Appeal of Planning Commission Resolution No. 26-02 Regarding Coastal Development Permit No. 21-045 and Variance No. 26-003 (24507 Vantage Point Terrace, APN 4458-033-006; Owner/Appellant, Meissner Family Trust)

Amended[1] Malibu City Council Special Meeting Agenda

Prepared by: Courtney Brown, Senior Planner

Subject: Appeal of Planning Commission Resolution No. 26-02 Regarding Coastal Development Permit No. 21-045 and Variance No. 26-003 (24507 Vantage Point Terrace, APN 4458-033-006; Owner/Appellant, Meissner Family Trust)

Figure 2 – 1980 Aerial Image Provided by Applicant

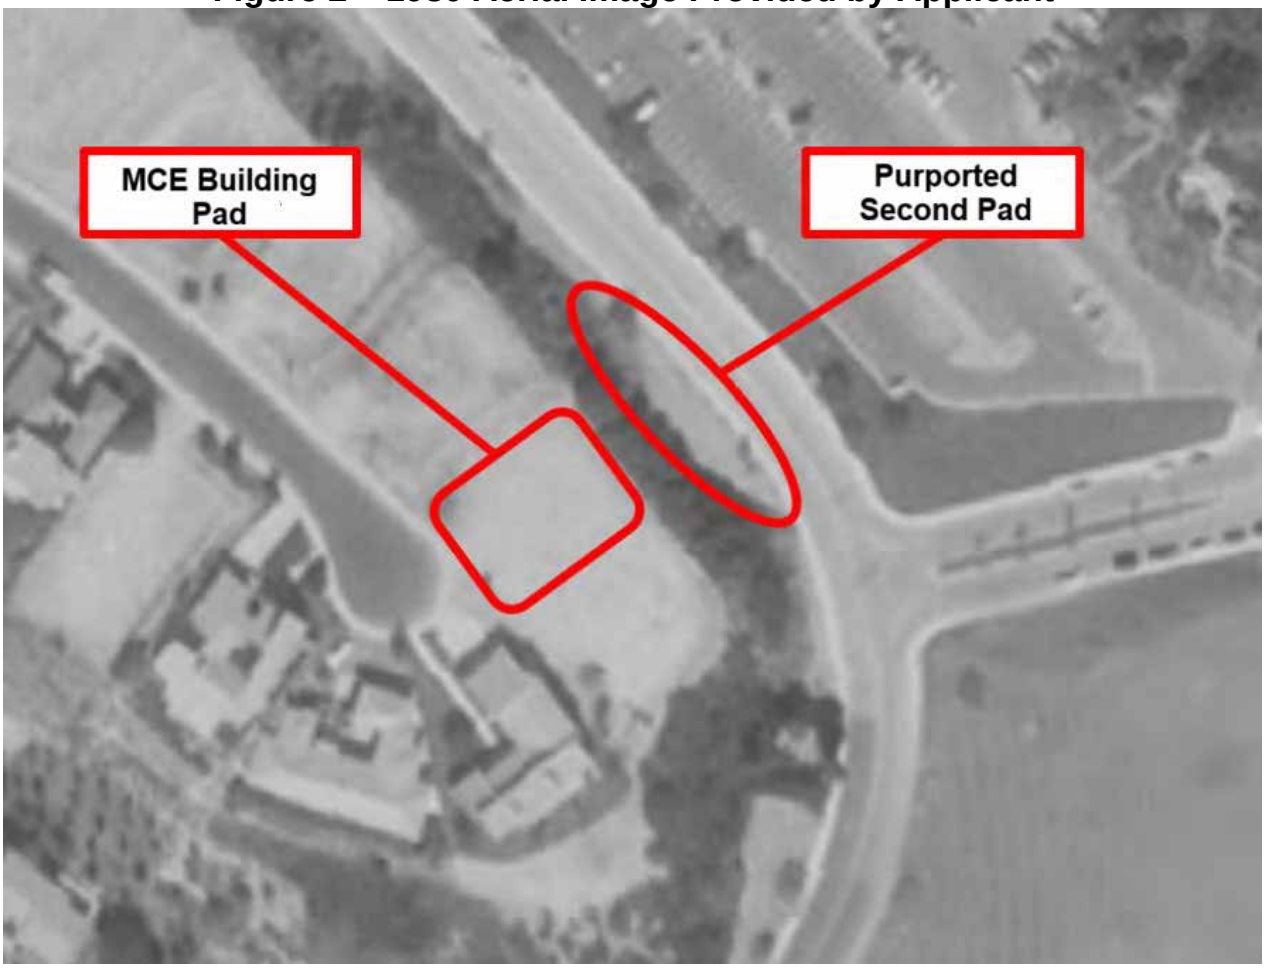
The applicant representative asserted that the 1980 image proves there are two building pads on the subject parcel – one near Vantage Point Terrace and a second downslope near John Tyler Drive where the proposed ADU/Second Unit is located. Based on the Planning Division's review, the purported second building pad referenced on the 1980 image is not typical of graded building pads within the MCE Overlay and appeared to be typical vegetation clearing along a roadway and/or vehicle shoulder/turnout along the west side of John Tyler Drive. The same type of cleared area extends onto other MCE Overlay parcels along John Tyler Drive. Additional research conducted by the Planning Division demonstrated that there is no evidence of a second building pad having been graded as part of the MCE Overlay development. This was confirmed in an aerial image obtained by the Planning Division dated 1976, as shown in Figure 3, dated four years prior to the 1980 image.

Figure 2 – Applicant 1980 Aerial Image

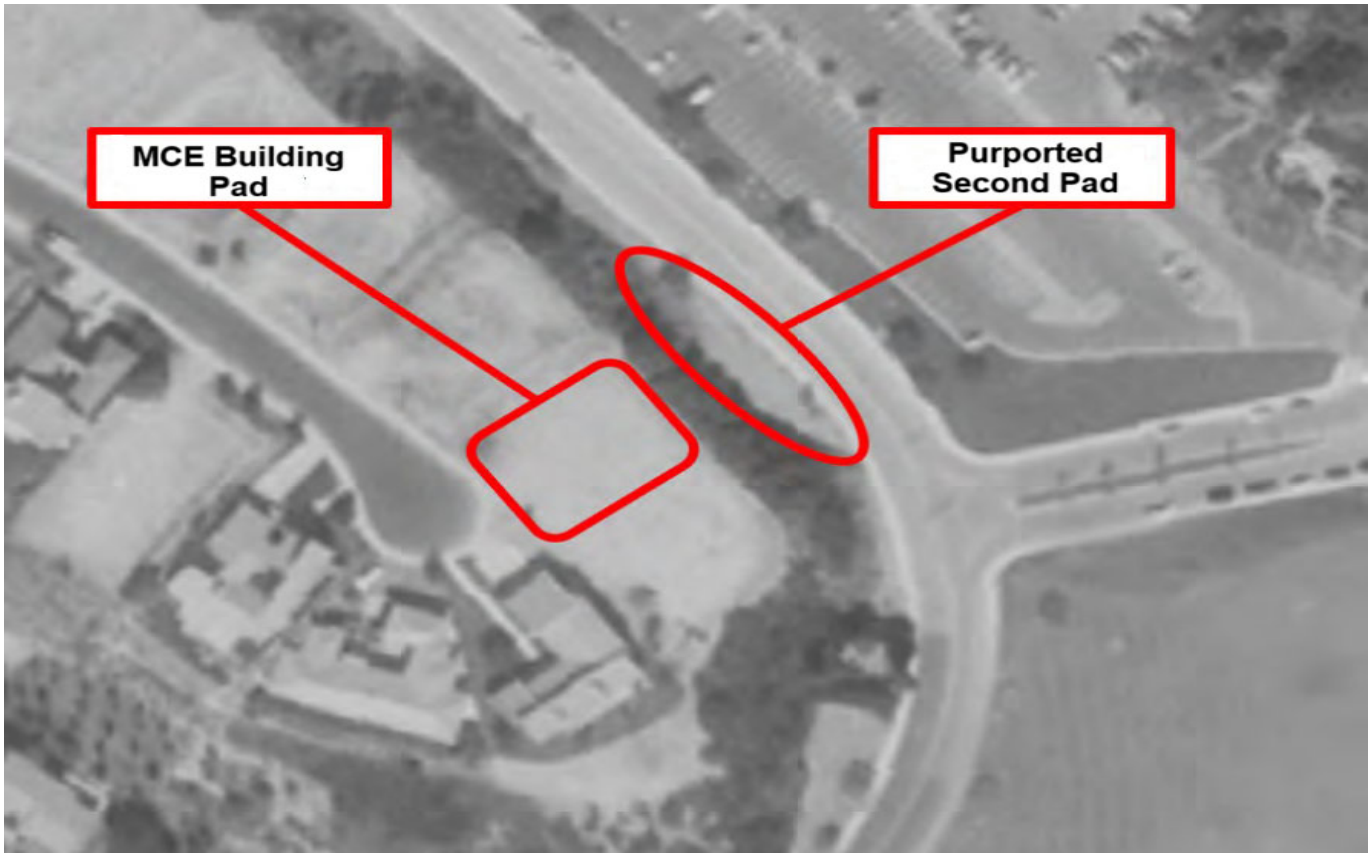
The rebuttal package included a historic aerial image from 1980 shown in Figure 2. The applicant representative asserted that the 1980 image proves there are two building pads on the subject parcel – one near Vantage Point Terrace and a second downslope near John Tyler Drive. Based on the Planning Division's review, the purported second building pad referenced on the 1980 image is not typical of graded building pads within the MCE Overlay and appeared to be typical vegetation clearing along a roadway and/or vehicle shoulder/turnout along the west side of John Tyler Drive. The same type of cleared area extends onto other MCE Overlay parcels along John Tyler Drive. Additional research

conducted by the Planning Division demonstrated that there is no evidence of a second building pad having been graded as part of the MCE Overlay development. This was confirmed in an aerial image obtained by the Planning Division dated 1976, as shown in Figure 3, dated four years prior to the 1980 image. The 1976 image more clearly depicts one building pad for the subject parcel adjacent to Vantage Point Terrance, similar to other parcels in the MCE Overlay. Even if there was a legally authorized second building pad, which the evidence does not suggest there is, the MCE Overlay district requires that development be limited to one building pad. This requirement is codified in both the LCP and MMC.

Figure 4 – Site Plan

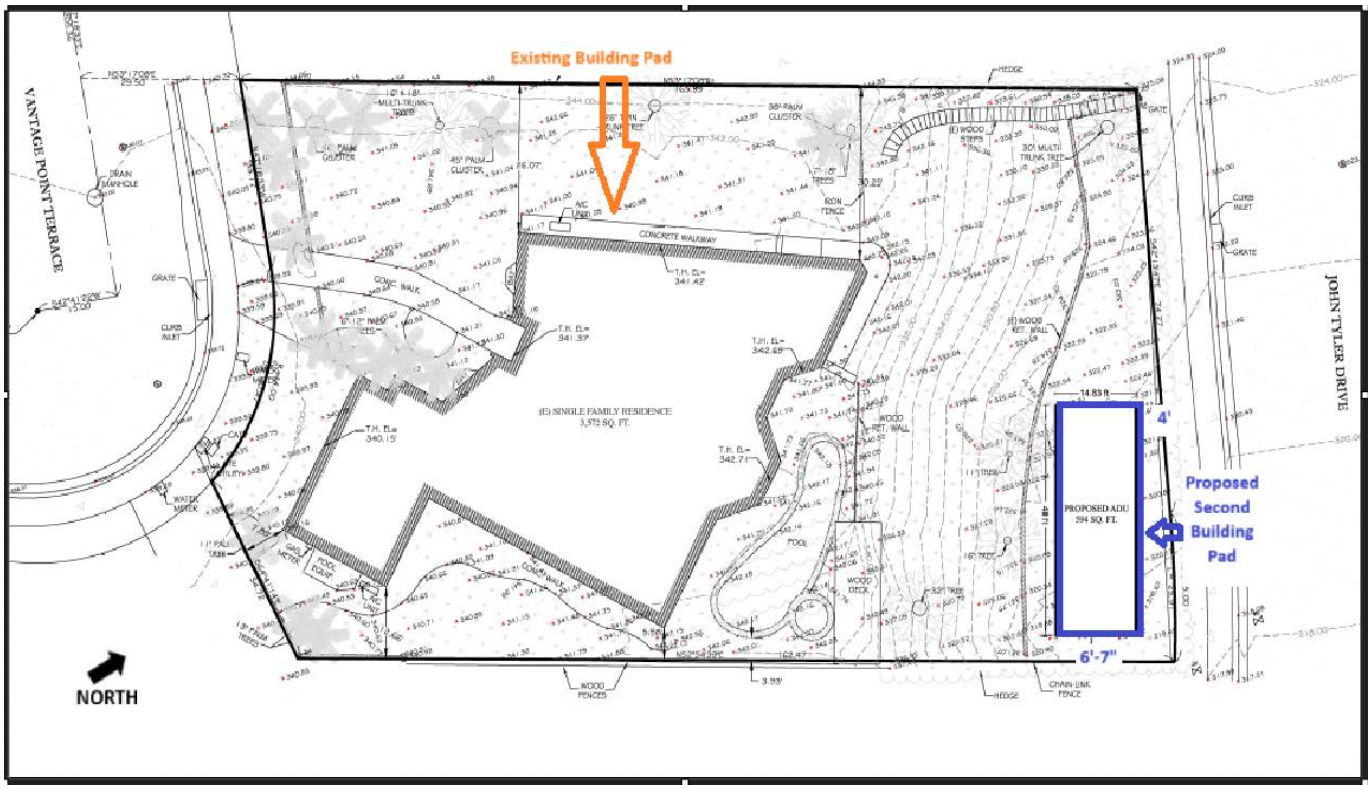
In Figure 4, the existing building pad is located at the top of the slope accessed from Vantage Point Terrace. The existing building pad includes a residence, garage, driveway, front and side yards, walkways, swimming pool, spa, and wooden deck. The proposed 14.83-foot by 40-foot prefabricated ADU/Second Unit is shown on the rear portion of the parcel downhill from the existing building pad. The ADU/Second Unit is proposed with a 4-foot rear yard setback and a 6-foot 7-inch interior yard setback.

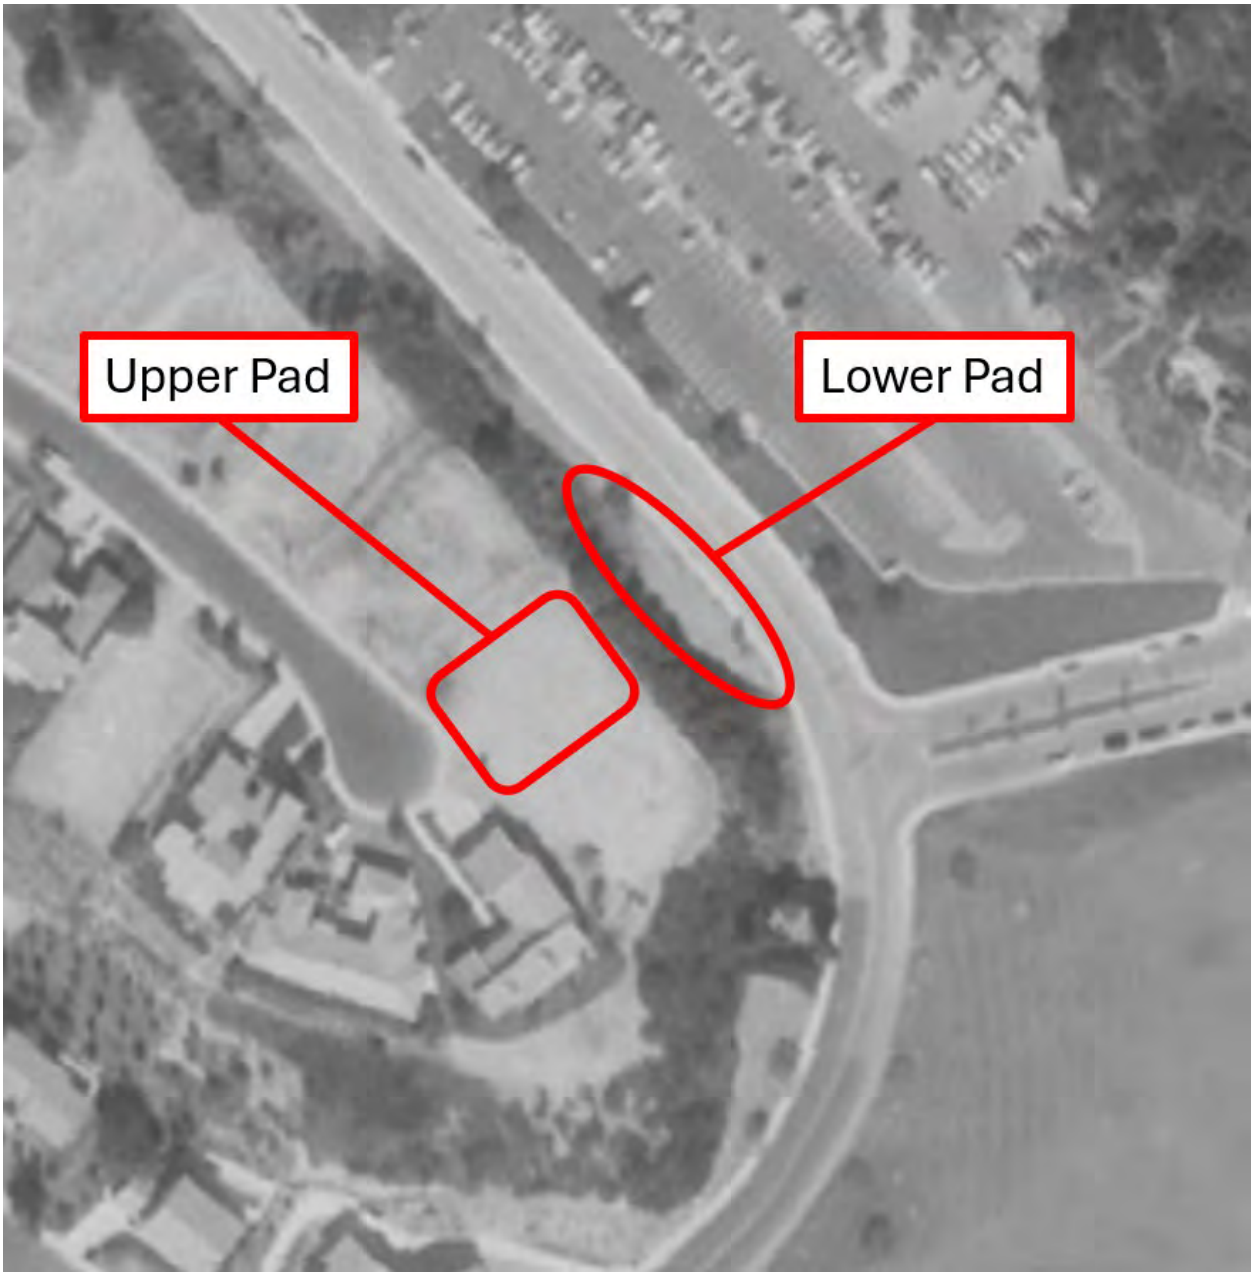
The 1980 aerial photograph further confirms the presence of a second lower pad on Lot 85.
